# Architectural Review Board Report

**Architectural Review Board Meeting: March 2, 2020**

**Agenda Item: 7.3**

To: Architectural Review Board  
From: Rathar Duong, Associate Planner  
CC: Stephanie Reich, AIA, LEED AP, Design and Historic Preservation Planner  
Regina Szilak, ARB Liaison  
Subject: 20ARB-0010 to approve the design, colors, materials, and landscape plans for the construction of a new two-story, approximately 29.5 feet high, 27,230 square-foot condominium project comprised of 19 residential dwelling units and 43 subterranean parking spaces located on four adjoining lots within the R2 district.  
Address: 2002-2018 21<sup>st</sup> Street (2020 Virginia Avenue)  
Applicant: Park Virginia, LLC

*Revised Site Plan*

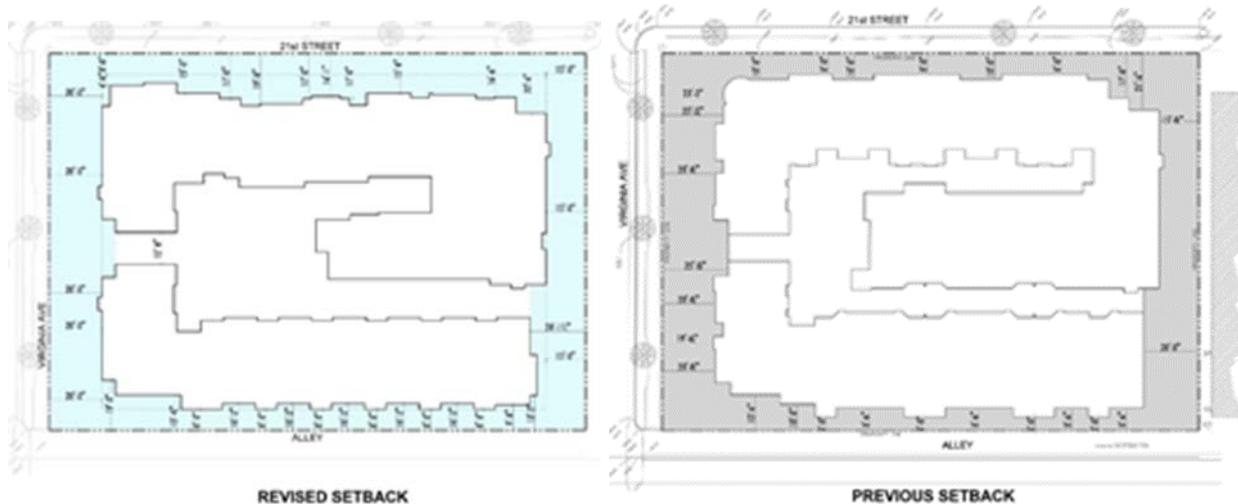
The townhouse units are arranged in two buildings organized around a central courtyard punctuated with a primary entry portal from Virginia Avenue that connects to a secondary opening east of the site which leads to the rear of the property. Placement of the main entry off of Virginia Avenue as well as entrances to individual units along 21<sup>st</sup> Street and entry to the subterranean parking level from the alley activate street frontages providing a design that is pedestrian-oriented. Trash/recycling area is located directly off the alley towards the front of the property as required and approved by Refuse, Recovery, and Recycling (RRR) Division.

The placement of the buildings shown on Sheet A2.2 meets or exceeds all required minimum setback and provides additional opportunities and flexibility for a varied and attractive landscape design and outdoor living spaces that further enhance the livability and quality of the units.
